INCH-POUND
MIL-F-24724/1(SH)
AMENDMENT 1
2 June 1992

MILITARY SPECIFICATION SHEET

FILTER HOUSINGS (HYDRAULIC) AND DIFFERENTIAL PRESSURE INDICATORS
(1, 2, 3 ELEMENTS)

This amendment forms a part of MIL-F-24724/1(SH), dated 15 February 1990, and is approved for use by the Naval Sea Systems Command, Department of the Navy and is available for use by all Departments and Agencies of the Department of Defense.

FIGURE 1. Filter housing.

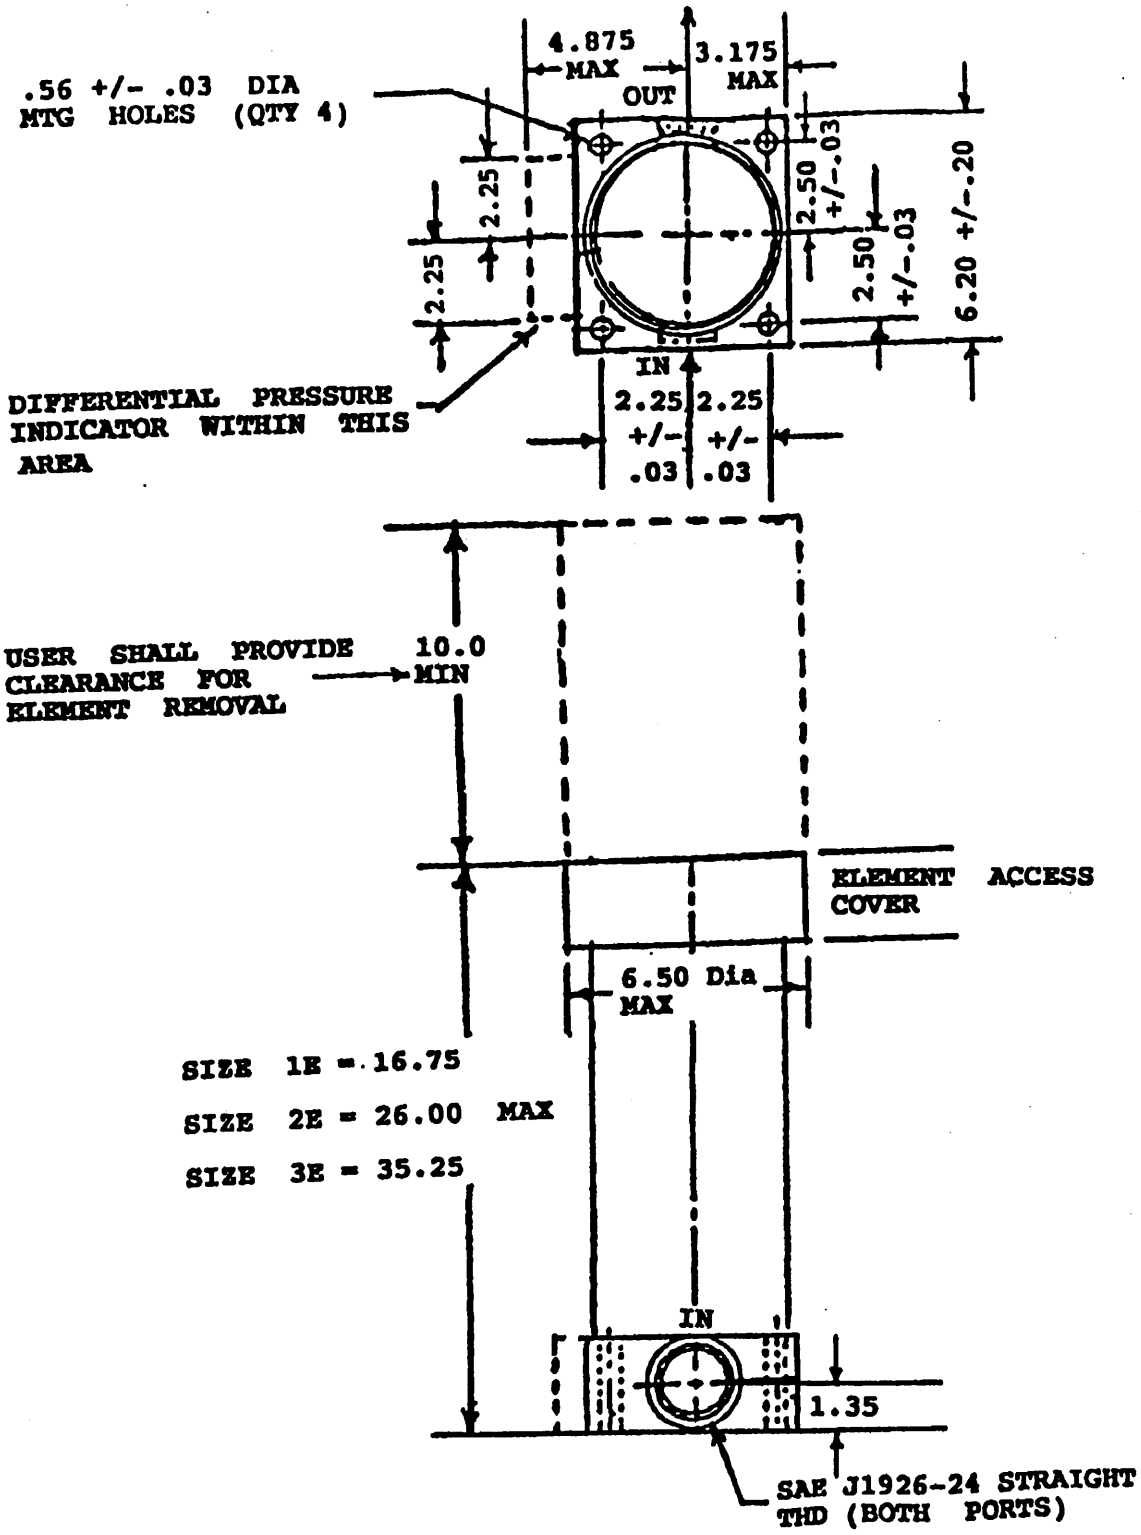
FIGURE 1: Delete and substitute the attached.

Under "NOTES", item 5: Delete "be 7.50 inches maximum." and substitute "not exeed 10.0 inches".
